ADDENDUM No. 3

REQUEST FOR QUOTATIONS No.:	1220-040-2024-045
TITLE:	TENANT IMPROVEMENTS OF BRIDGEVIEW CHILDCARE CENTRE
ADDENDUM ISSUE DATE:	SEPTEMBER 5, 2024
CLOSING DATE:	PREFER TO RECEIVE SUBMISSION ON OR BEFORE SEPTEMBER 11, 2024

1 REVISED LIGHTING AND LIFE SAFETY LAYOUT
E2.0

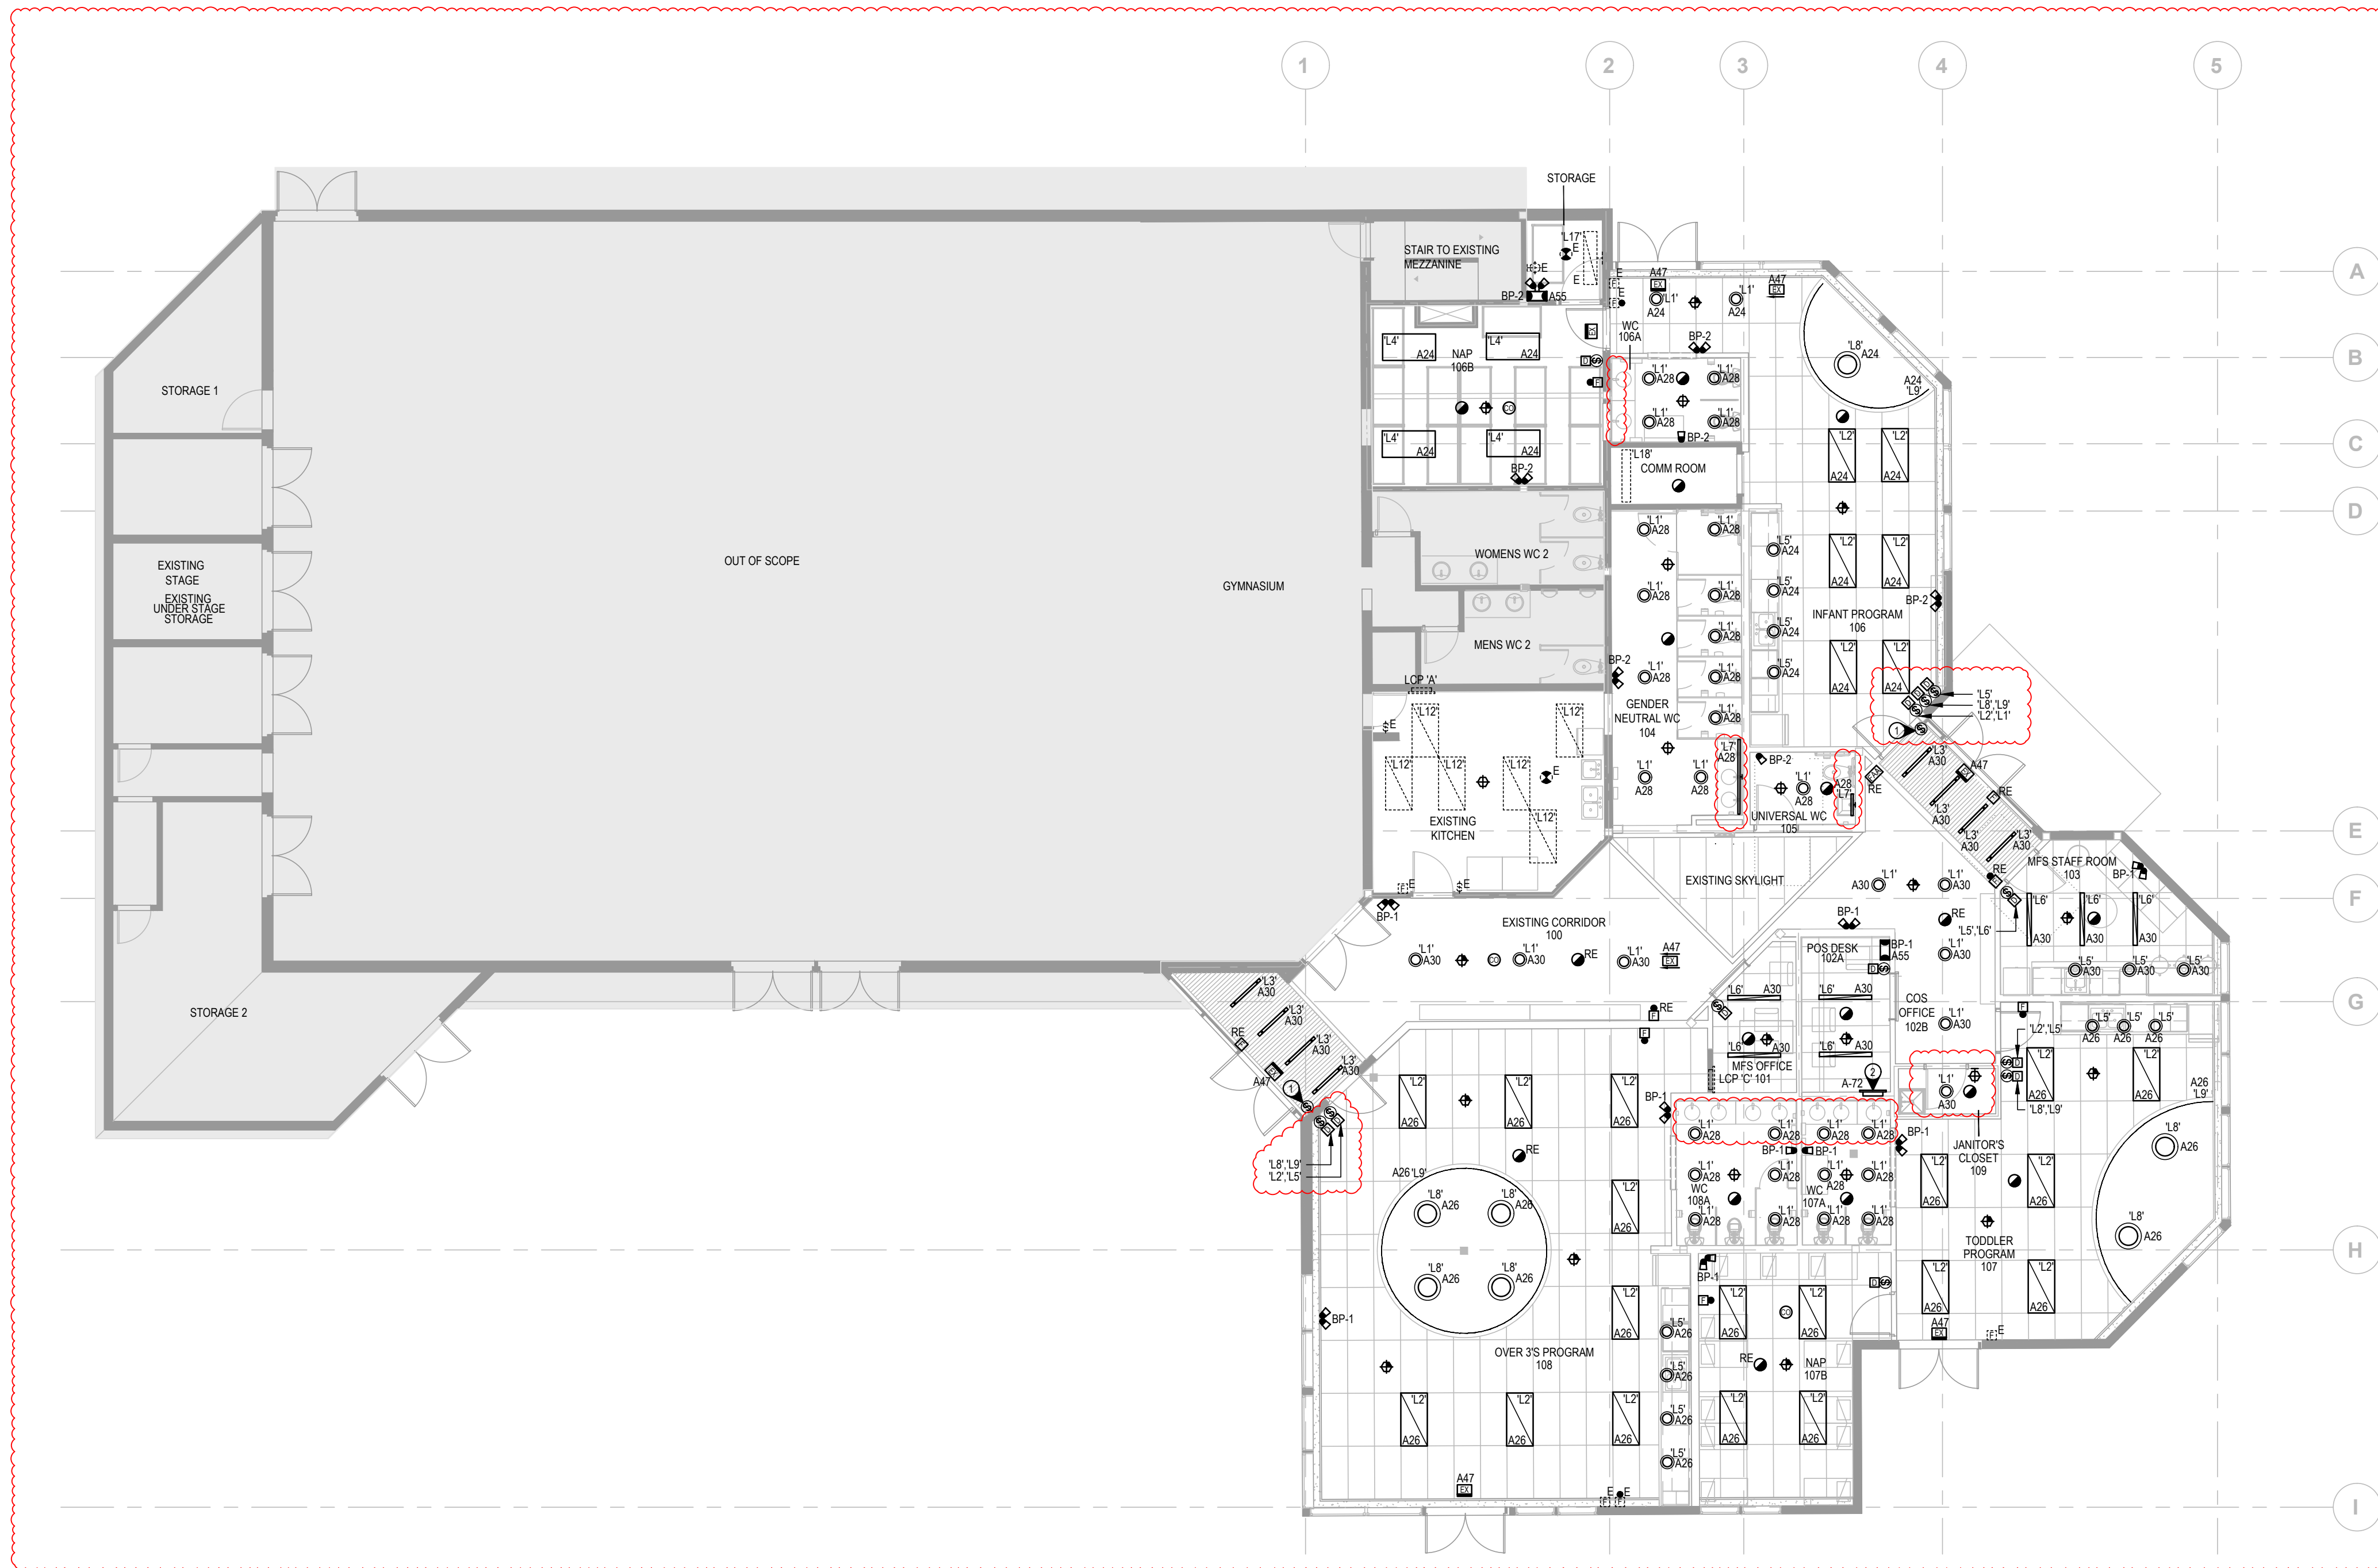
1. Sheet E2.0 – Revised Lighting and Life Safety Layout

- .1 Deleted (1) L7 in each room at 106A, 107A, 108A.
- .2 Added (2) L1 in each room at 107A and 108A.
- .3 Revised the location of L7 in 105 to suit the updated layout.
- .4 Revised the length of L7 in 104 to suit the updated layout.
- .5 Revised the location of switches in 100, 106, 108, 109 suit the updated layout.
- .6 Revised the lighting layout as per updated RCP plan.

1 REVISED POWER AND SYSTEMS LAYOUT
E2.1

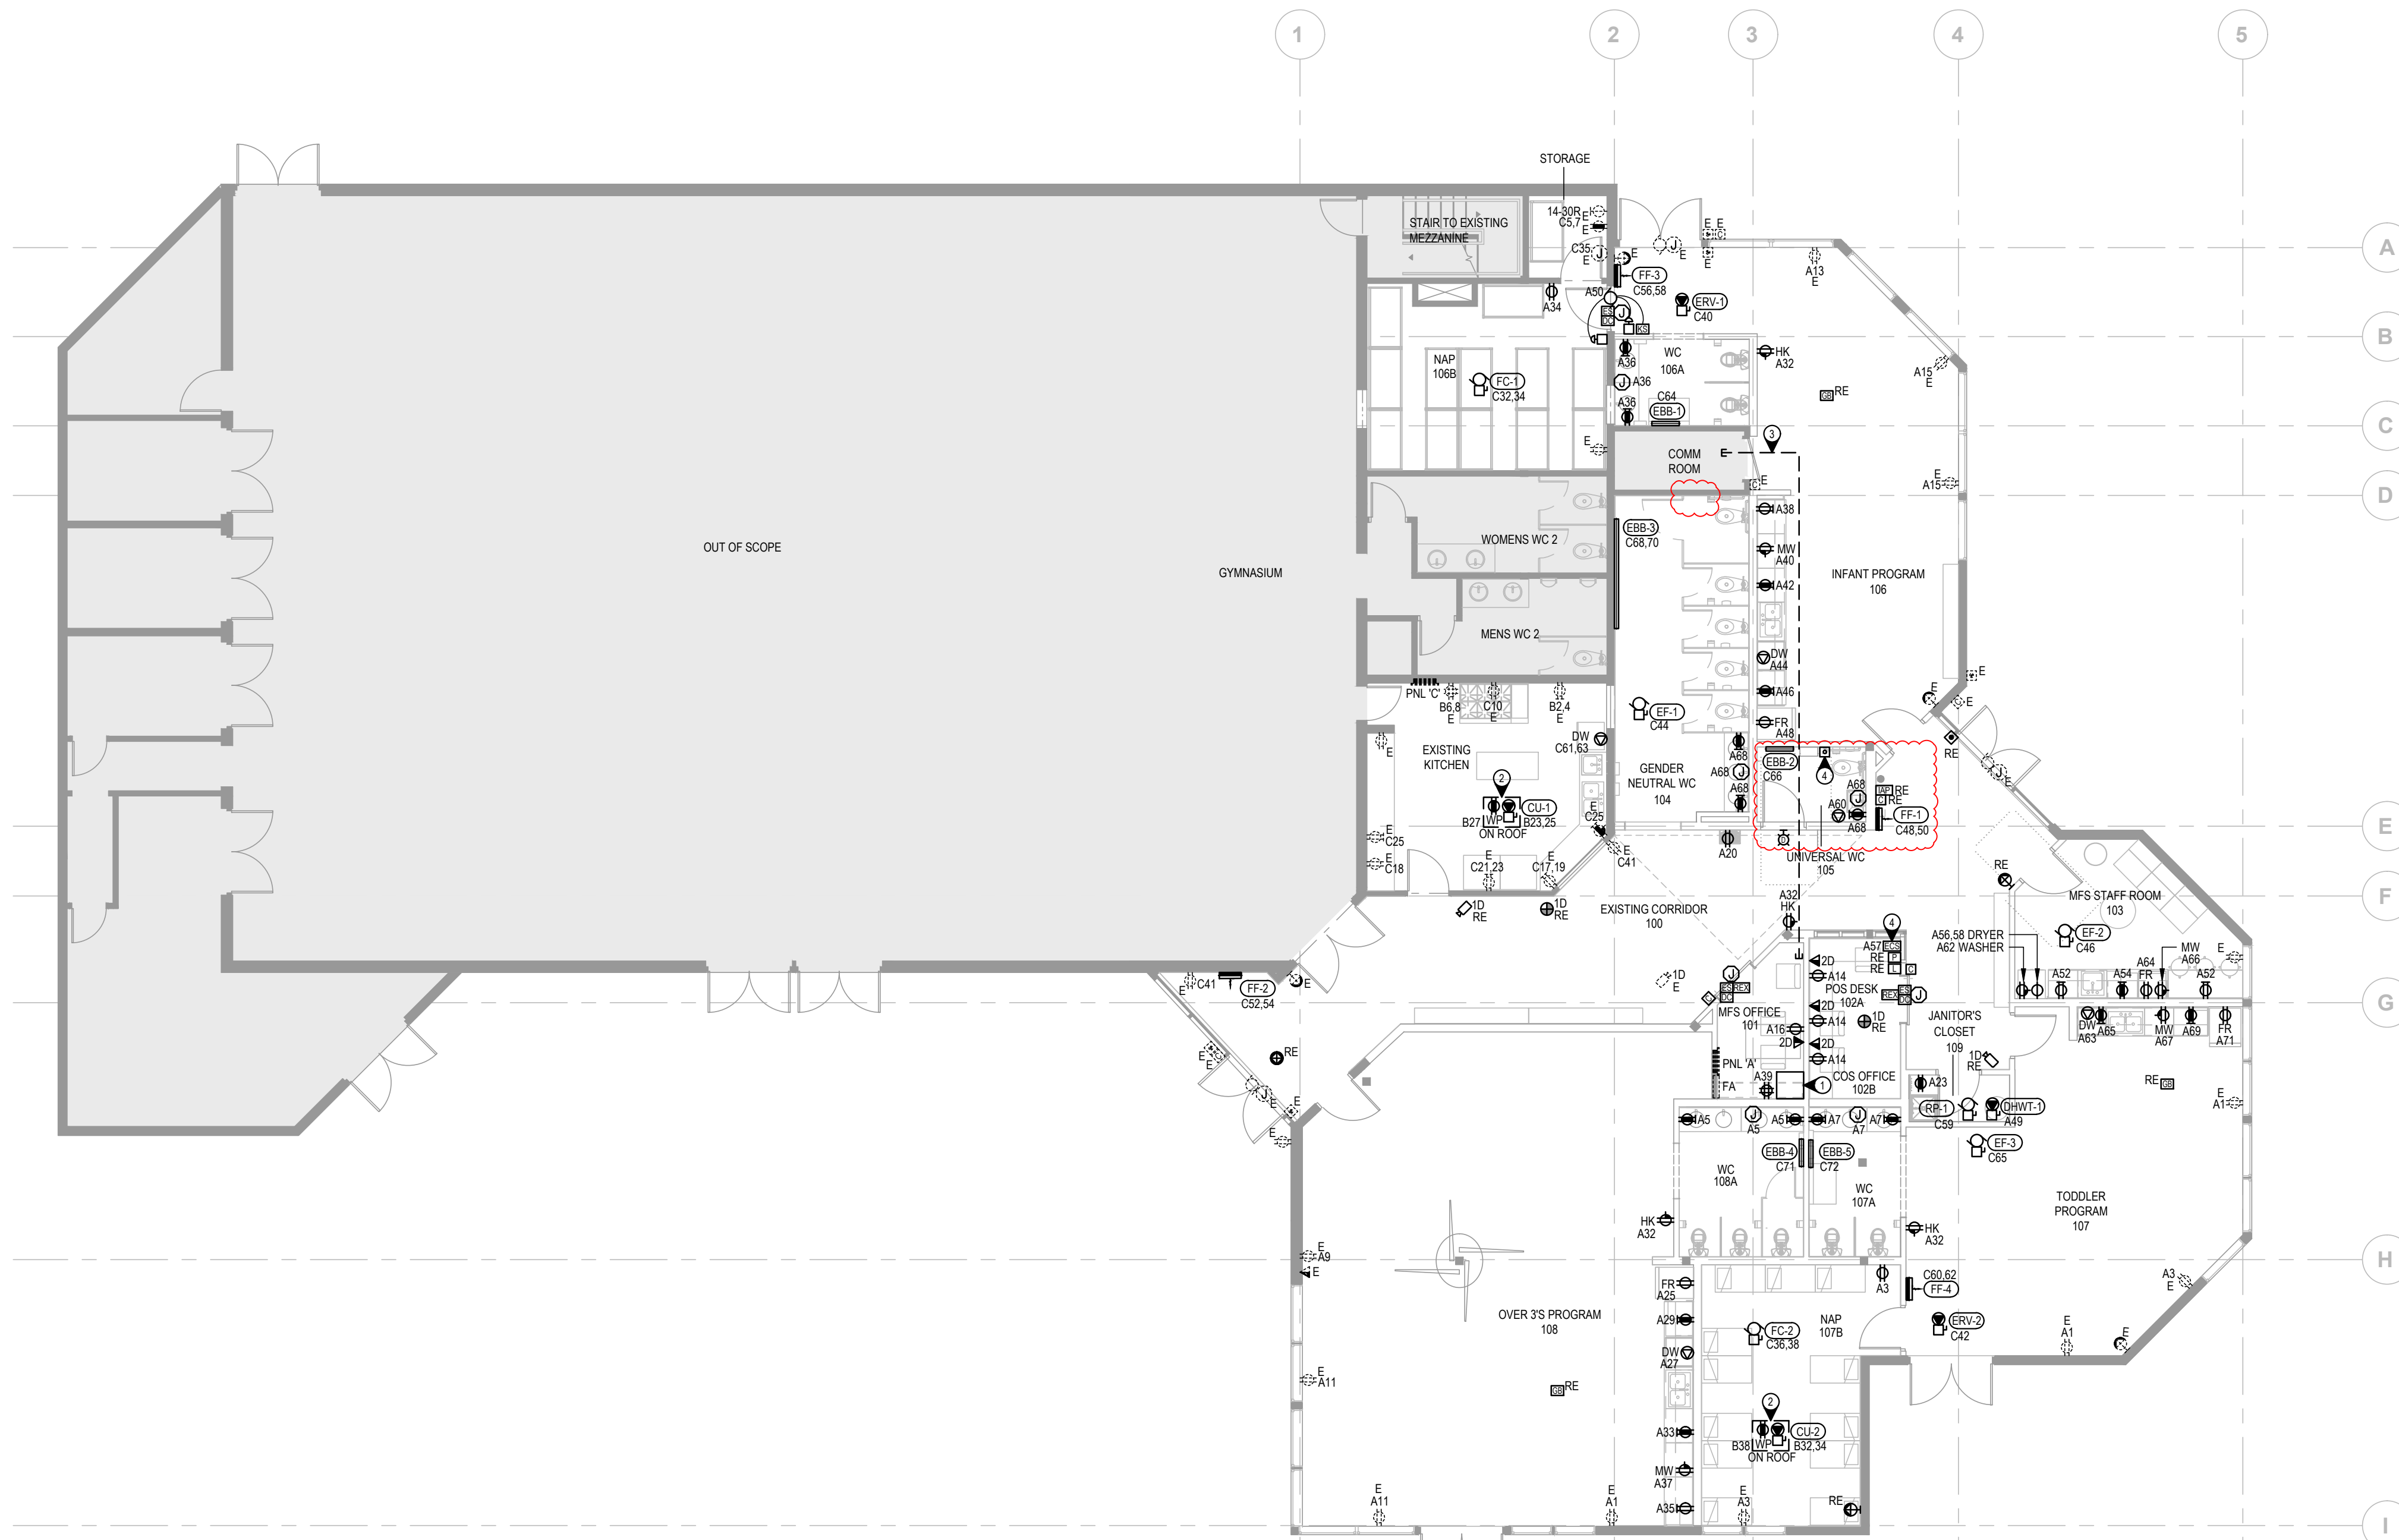
2. Sheet E2.1 – Revised Power and Systems Layout

- .1 Revised the location of electrical in universal WC 105.
- .2 Deleted (1) emergency call button in gender neutral WC 104.

9 NEW & EXISTING WALL CONNECTION @ RM 106
A7.00 PLAN DETAIL 1:5

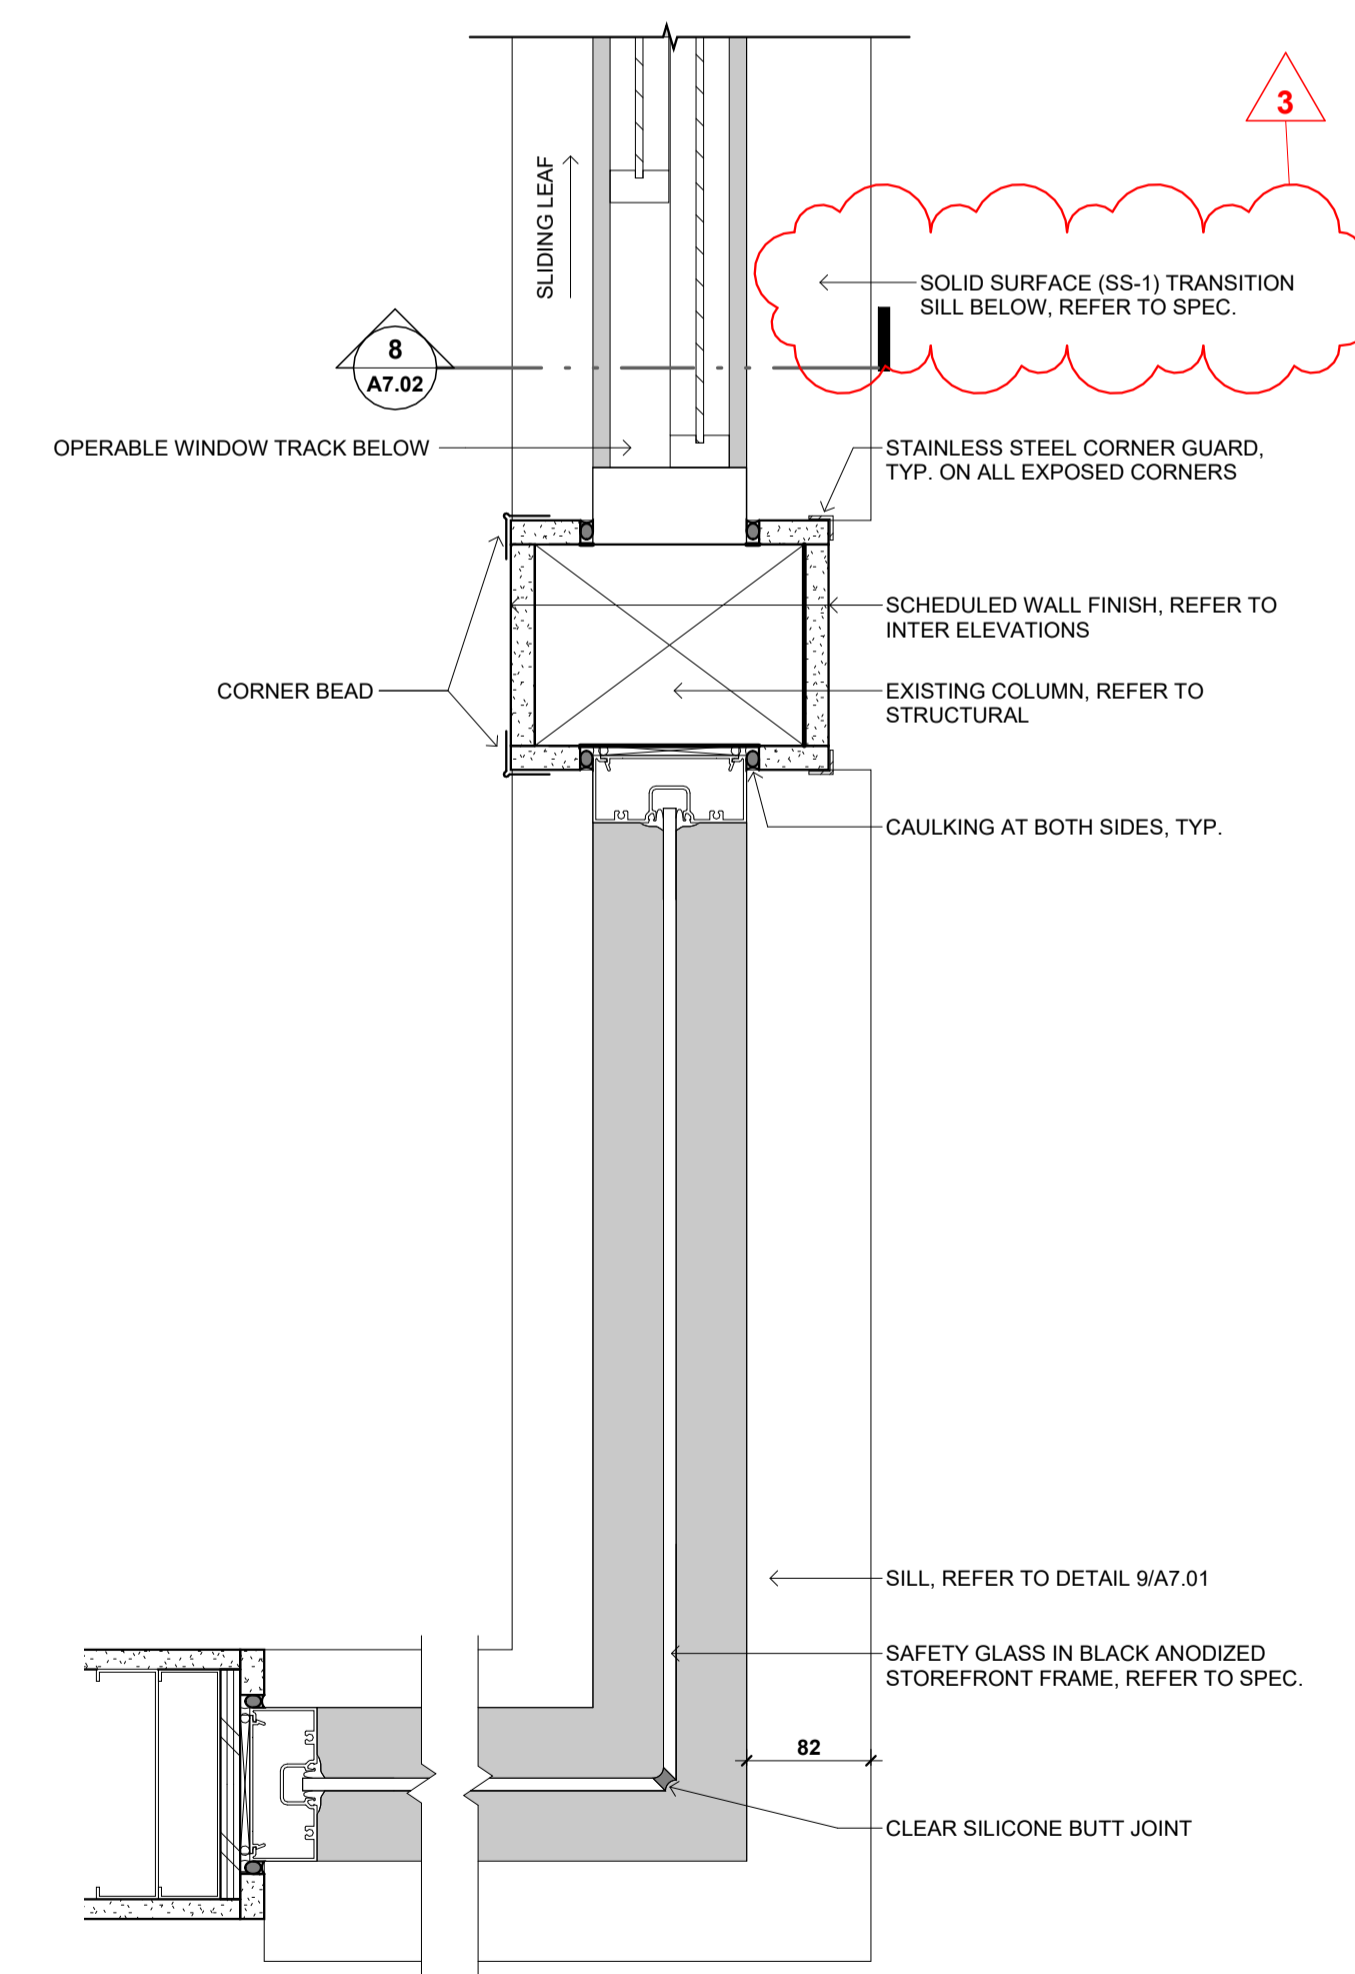
- 2.1 Revised detail #9.
- 2.2 New column detail #10 including material instructions.
